AERONAUTICAL CHARTING FORUM
Instrument Procedures Group
April 29-30, 2002
HISTORY RECORD

FAA Control # 02-01-241

Subject: Non-radar Level and Climbing Holding Patterns

KAILUA-KONA, HAWAII
ILS DME Rwy 17

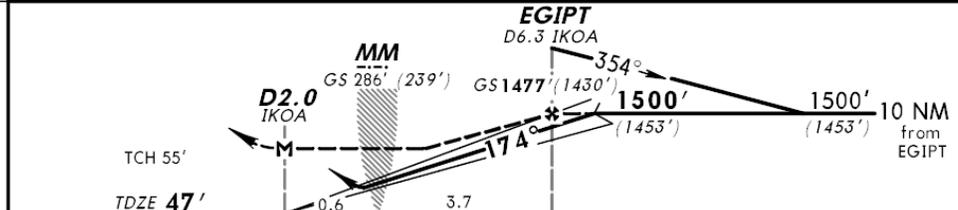
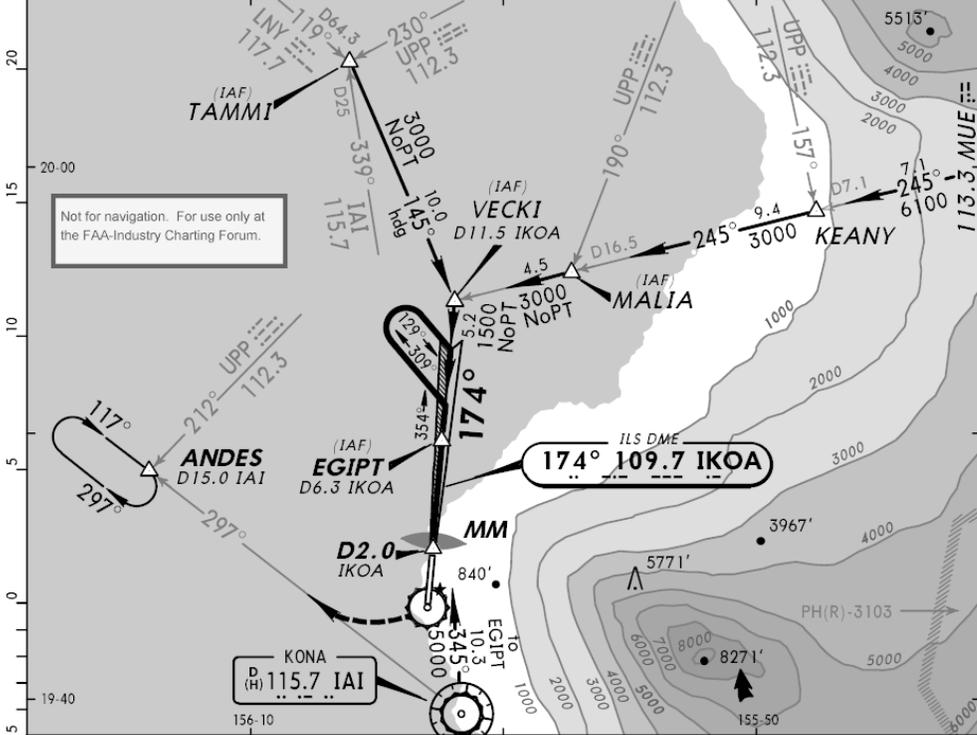
Background/Discussion: FAA holding pattern criteria and policies provide for 310-knot climb-in-hold (CIH) holding patterns for missed approach procedures used by jet airplanes where a 40:1 surface is penetrated in accordance with the criteria contained in 8260.3B, Paragraph 293b. Pilots have no way of knowing, however, which CIH patterns have been evaluated for CIH. Also, there are situations where a jet airplane CIH pattern does not trigger the provisions of 8260.3B, Paragraph 293b, so the pattern size used often provides for a maximum of 200 knots even though a modified CIH may be required. An example is attached, for the ILS 17 at Kona, Hawaii, (illustration attached) where the missed approach holding pattern is 40:1-free, and the holding altitude is 1,500 feet. But, a CIH to at least 5,000 is required to return to the approach procedure. Pilots have no way of determining what the maximum design speed is for CIH in any holding pattern. 200 knots is an inadequate speed for a transport jet airplane to climb in the Kona pattern, although 310 knots would be excessive.

Recommendation: CIH patterns such as in the Kona ILS 17 example, and all patterns used by jet airplanes where CIH is required, should be evaluated for 265 knots where 310-knot CIH patterns are not required. This requirement should extend to holding patterns for both missed approaches and DPs. Further, it should be made clear that the 310-knot CIH criteria apply to DP holding patterns where a Paragraph 293b evaluation finds 40:1 penetrations. Pilots should be informed, both by AIM reference material, and chart code, which patterns are authorized for 265-knot CIH and which are authorized for 310-knot CIH. Further, en route patterns that are evaluated for 280-knot turbulence holding should be clearly coded.
